SUBJECT: Customer Satisfaction Program 17M04 - *Supplement #2*
Certain 2014-2016 Model Year F-250 – F-550 and 2016 Model Year F-650 - F-750
Vehicles, With 6.7L Diesel Engine
Crankcase Ventilation Oil Separator Assembly

New! REASON FOR THIS SUPPLEMENT

- *SERVICE ACTION: A new service repair for F-250 – F-550 vehicles, which eliminates the need to replace the crankcase ventilation (CCV) oil separator assembly, is now available.*

FIGURE 1

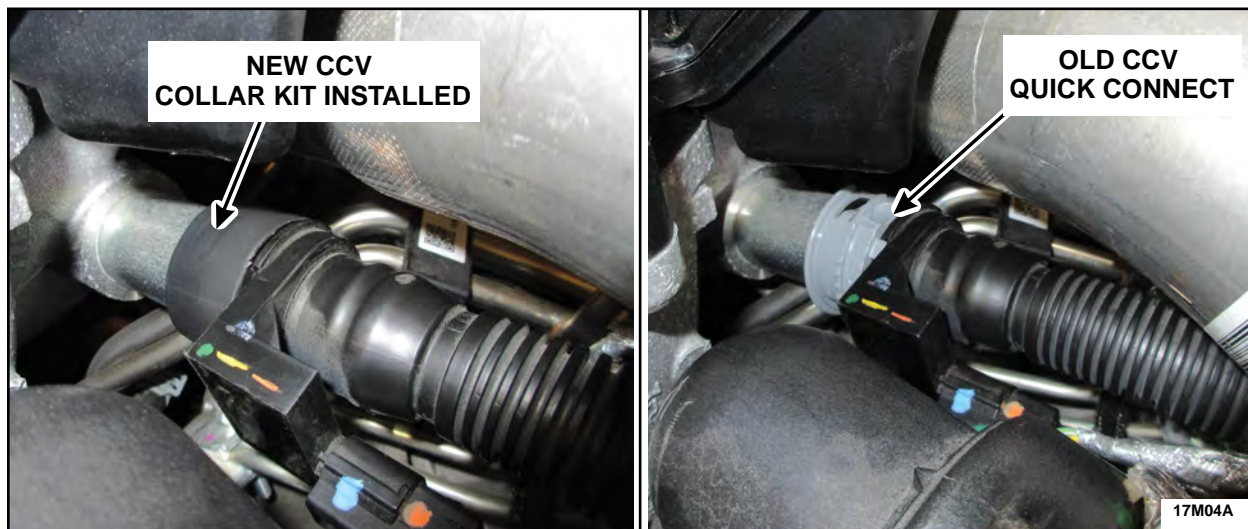
1. Using IDS check for the following DTC's: P04DB, P04E2, and P04E3.
 - If one of more of the DTCs are present, install a CCV collar kit.
 - Reprogram the PCM Using IDS R110.01 or Higher.
2. If none of the above DTCs are present, and a CCV collar kit is not already installed on the CCV oil separator assembly, and reprogramming the powertrain control module (PCM) is required for another concern, the dealer will install a CCV collar kit on the CCV oil separator assembly. If a CCV collar kit has previously been installed on the CCV oil separator assembly, this program does not apply. See Figure 1.

⚠ WARNING: Do not proceed with a calibration update if the CCV collar kit has not been installed at the crankcase vent oil separator outlet hose to the intake manifold connection. The CCV collar kit is a permanent connection and has a black in color smooth sleeve around the outside of the collar with no visible locking tabs. The previous level quick connection lock ring may be gray or black in color and includes visible locking tabs and raised teeth around its circumference. Failure to install the CCV collar kit permanent connection prior to flashing the PCM with a calibration update will result in violation of U.S federal and certain state emissions laws. Refer to the latest supplement for FSA 17M04 for further information regarding installation of installing the CCV collar kit.

FIGURE 2

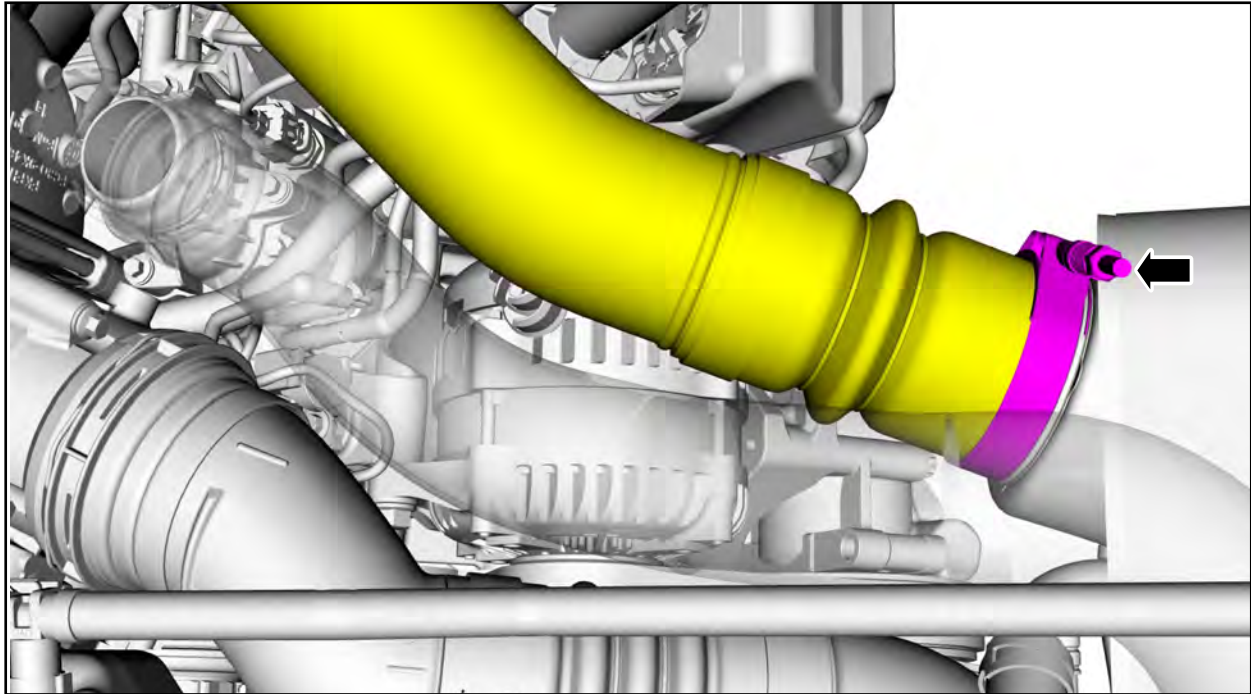
3. Loosen the clamp and disconnect the Charge Air Cooler (CAC) inlet tube from the CAC and position aside. See Figure 2.

8. Connect the Charge Air Cooler (CAC) inlet tube to the CAC and tighten the clamp. See Figure 2.
- To install, tighten to 9 Nm (80 lb-in).

FIGURE 3

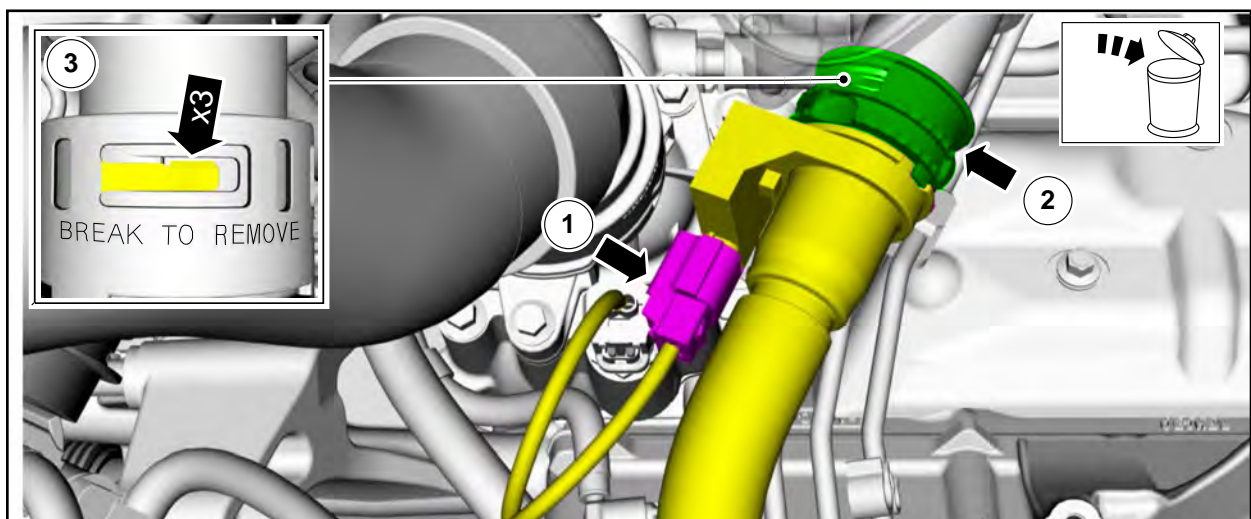
4. Remove the quick connect end crankcase vent oil separator outlet hose. See Figure 3.
 1. Disconnect the crankcase vent oil separator outlet hose sensor electrical connector.
 2. Disconnect and remove the crankcase vent oil separator outlet hose from the intake manifold by turning the release ring counterclockwise.
 3. Remove the quick connect end from the hose by twisting clockwise and pulling at the same time, break the retaining tabs as needed. Discard the old quick connect.

FIGURE 4

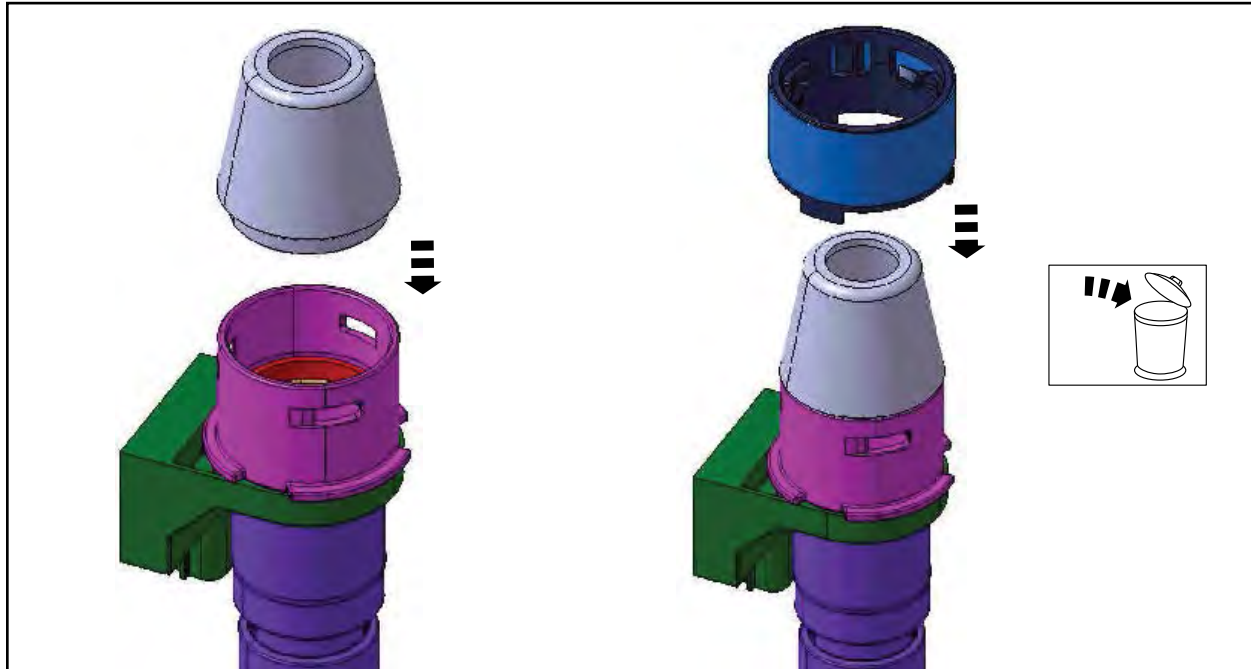
5. Place the installation cone into the end of the crankcase vent oil separator outlet hose. See Figure 4.
6. Install the *new* CCV collar over the installation cone and twist to lock into place. Remove the installation cone and discard. See Figure 4.

NOTE: The tabs on the CCV collar should be pointing down.

FIGURE 5

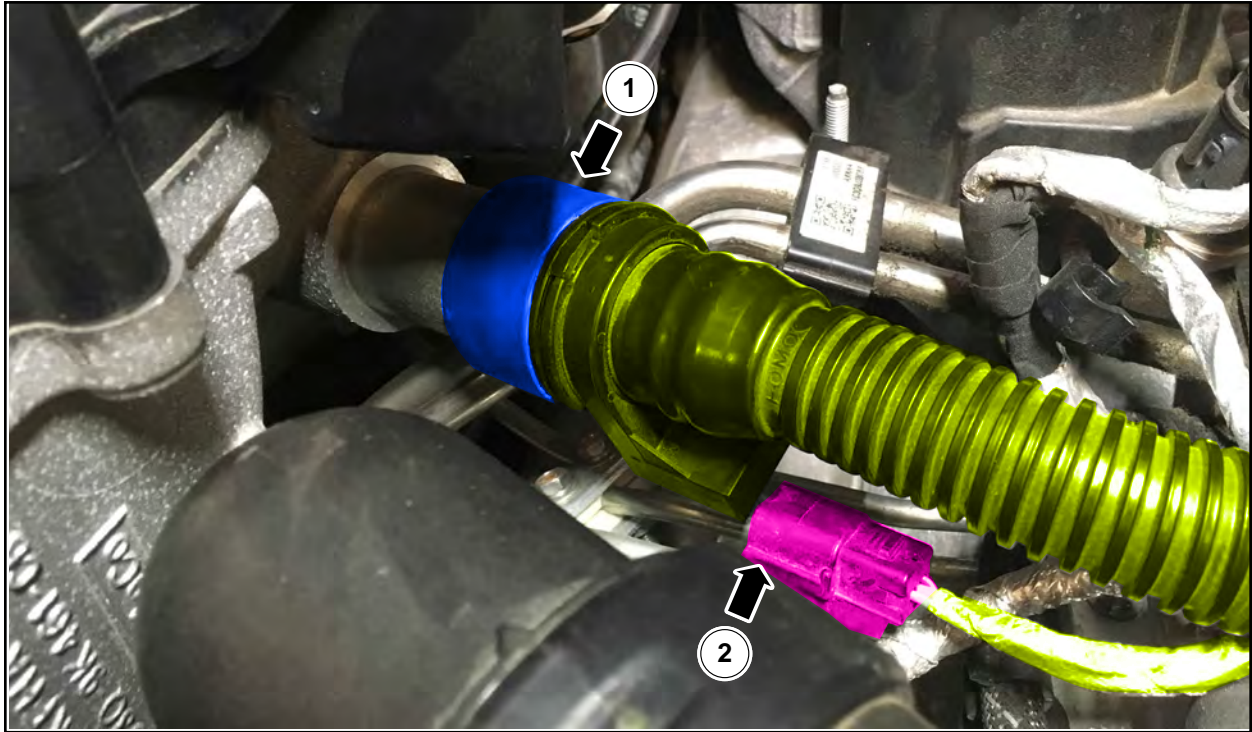
7. Connect the crankcase vent oil separator outlet hose to the intake manifold (1) and connect the electrical connector (2). See Figure 5.
